SERVICE BULLETIN

Subject: Envoy AGM Battery Clamp Mounting**Date: 2/13/14****Bulletin No. SB14-2**

Figure 1

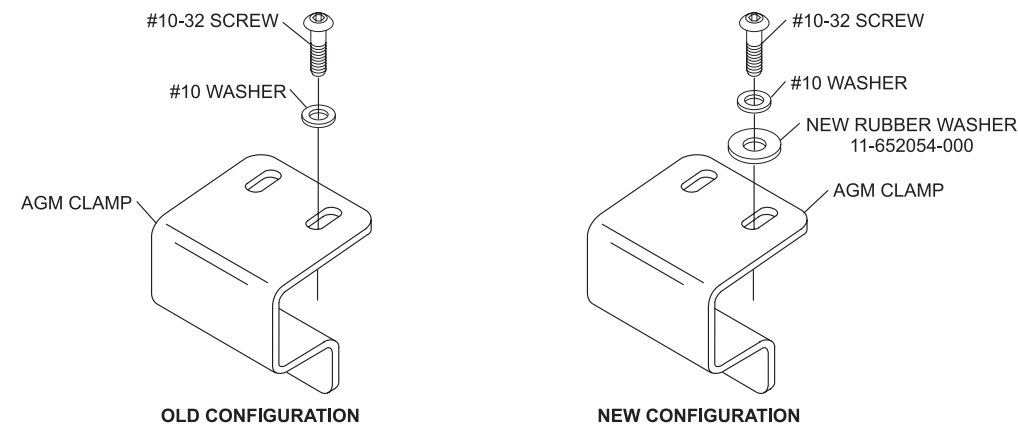
It has come to our attention that on Envoy Lane Machines, serial numbers 3001-3090, the clamps holding the AGM batteries into the Envoy Lane Machine battery tray could be too tight and may cause excessive pressure on the AGM battery when secured.

We have an updated mounting configuration for the clamp to require an extra rubber washer between the metal washer and the bracket. Refer to Figure 1.

Parts Required: 4 each, rubber washer, part # 11-652054-000

To install, remove the #10-32 screw and #10 washer and insert the new rubber washer, part number 11-652054-000, between the #10 washer and the AGM battery clamp as shown in Figure 1, "New Configuration." Tighten the screws on the clamp until they are snug. This will allow the rubber washer to cushion the clamping force without over tightening the clamp.
